# Product Change Notification

Product Change Notification: E-20-016603

HEADER ASSEMBLY, 8,14,23,35 POSITION, RIGHT ANGLE, AMPSEAL,VERTICAL,AMPSEAL WITH FLANGE SEAL

Picture:

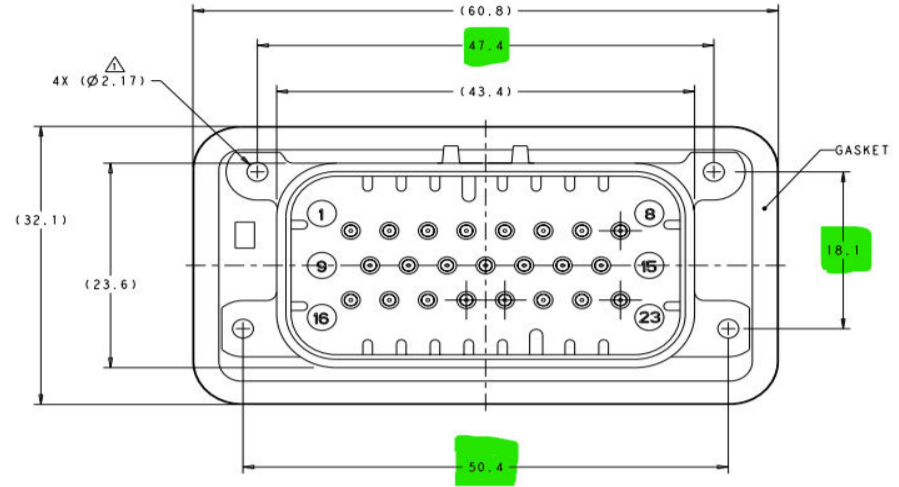
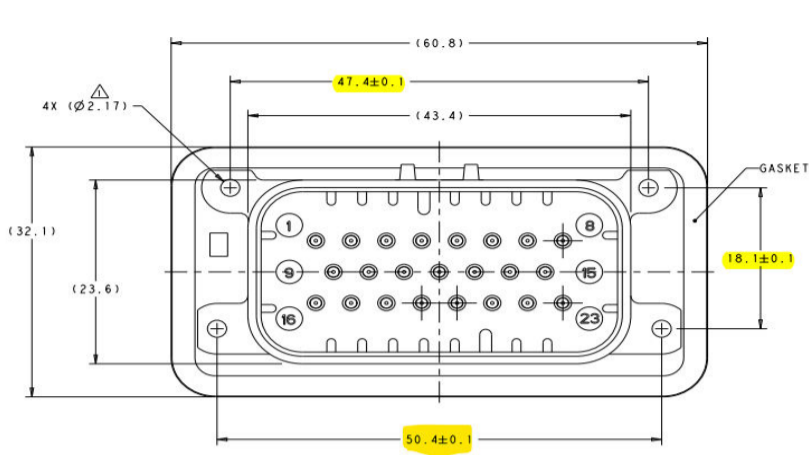
ZONED7 view the mounting holes, been removed the +/-0.1 tolerance value
